British Gliding Association Aircraft Inspection

Number: 003/08/2000	Issue: 1
------------------------	-------------

- Subject: Ka8 Suspect Elevator drive disconnection
- Applicability: Schleicher Ka2, 2b, 6, K7 & K8 (US 7G1, 7G3, 7G4)
- Accomplishment: By 30th September 2000 and Annually at C of A inspections.

Possible sources of mistakes in the automatically elevator connection
of the types Schleicher Ka 2 and Ka 2B, Ka 6, K 7 and K 8. (US 7G1, 7G3, 7G4)
This point should be given special attent at the inspections.

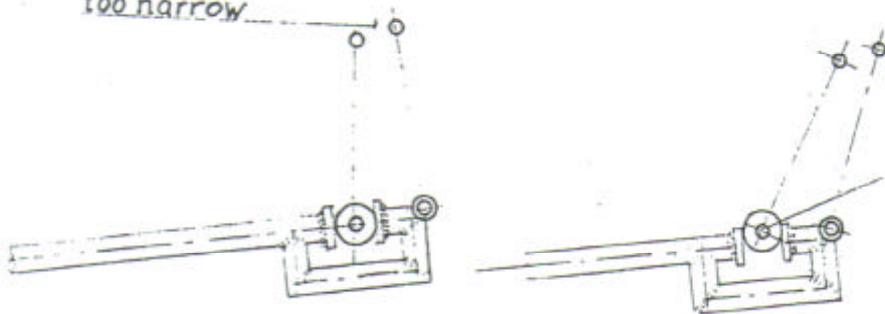
Must be in center.
or ballbearing
some what lower

$a_1 = a_2$

$b_1 = b_2$

b2 may be wider until
4 mm, in no case
smaller. Check it with
a pair of compasses.
Therefore disassemble
one half of elevator.

2. Ball bearing too high.

3. Parallelogram gearing not correct:

too narrow

goes out at deflection
"push".

A new bearing support
"B" is to be made with
adjusted measures if
the above dimensions
are not correct.
